# Access Compliance Report

## Public Rights-of-Way

### (Island Curb Cuts)

Intersection ID: 5600	Main Street: N_TRYON_ST	Cross Street: J_M_KEYNES_DR	Location: SW
ADA ID: CF35D4401F52	Curb Cut Type: MedianRefuge2	Initial Pass/Fail: Fail	Overall Compliance: No
Severity Score: 0			
Codes/Mitigation Info/Possible Solution		Field Measurements/Component Compliance

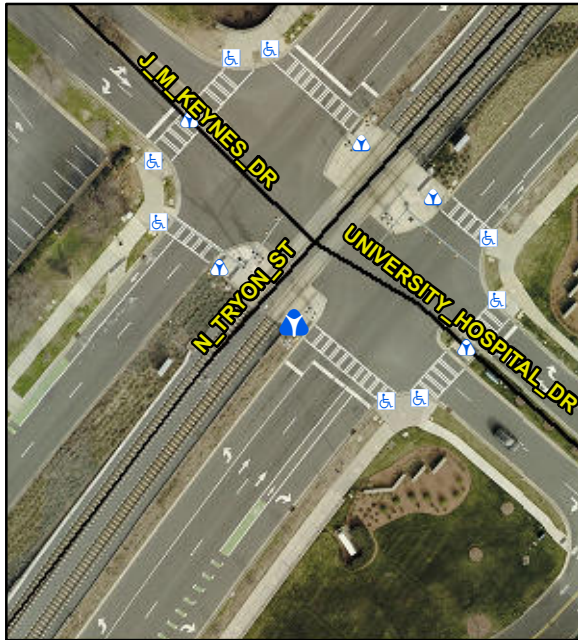
Compliance	Description	Data	Compliance	Description	Data
Yes	Refuge 1 Length (In)	47.0	N/A	Gutter 1 Ponding?	N/A
Yes	Refuge 1 Width (In)	120.0	N/A	Gutter 1 Lip Ht (In)	N/A
Yes	Refuge 1 Slope (%)	0.4	N/A	Gutter 1 Slope (%)	N/A
Yes	Refuge 1 X Slope (%)	1.0	N/A	Gutter 1 X Slope (%)	N/A
N/A	Painted X Walk1?	No	N/A	DWS 1 Provided?	N/A
N/A	X Walk 1 Direction	To NW	N/A	DWS 1 Contrast?	N/A
N/A	X Walk 1 Width (In)	N/A	N/A	DWS 1 Length (In)	N/A
N/A	Road 1 Slope (%)	0.0	N/A	DWS 1 Full Width?	N/A
N/A	Road 1 X Slope (%)	0.5	N/A	DWS 1 Offset (In)	N/A
Yes	Refuge 2 Length (In)	47.0	N/A	Gutter 2 Ponding?	N/A
Yes	Refuge 2 Width (In)	120.0	N/A	Gutter 2 Lip Ht (In)	N/A
Yes	Refuge 2 Slope (%)	1.7	N/A	Gutter 2 Slope (%)	N/A
Yes	Refuge 2 X Slope (%)	0.2	N/A	Gutter 2 X Slope (%)	N/A
N/A	Painted X Walk2?	No	N/A	DWS 2 Provided?	N/A
N/A	X Walk 2 Direction	To SE	N/A	DWS 2 Contrast?	N/A
N/A	X Walk 2 Width (In)	N/A	N/A	DWS 2 Length (In)	N/A

N/A	Road 2 Slope (%)	0.6	N/A	DWS 2 Full Width?	N/A
N/A	Road 2 X Slope (%)	0.3	N/A	DWS 2 Offset (In)	N/A
N/A	Refuge 3 Length (in)	N/A	N/A	Gutter 3 Ponding?	N/A
N/A	Refuge 3 Width (in)	N/A	N/A	Gutter 3 Lip Ht (in)	N/A
N/A	Refuge 3 Slope (%)	N/A	N/A	Gutter 3 Slope (%)	N/A
N/A	Refuge 3 XSlope (%)	N/A	N/A	Gutter 3 XSlope (%)	N/A
N/A	Painted X Walk3?	No	N/A	DWS 3 Provided?	N/A
N/A	X Walk 3 Direction	N/A	N/A	DWS 3 Contrast?	N/A
N/A	X Walk 3 Width (in)	N/A	N/A	DWS 3 Length (in)	N/A
N/A	Road 3 Slope (%)	N/A	N/A	DWS 3 Full Width?	N/A
N/A	Road 3 XSlope (%)	N/A	N/A	DWS 3 Offset (in)	N/A
Yes	Any Obstructions?	N/A	N/A	Storm Grate/Utility Hazard?	N/A
N/A	Obstruction Type		N/A	Storm Grate/Utility Type	
		N/A			N/A
N/A	Surface Condition	Good

**Remove & Replace Entire Refuge.**
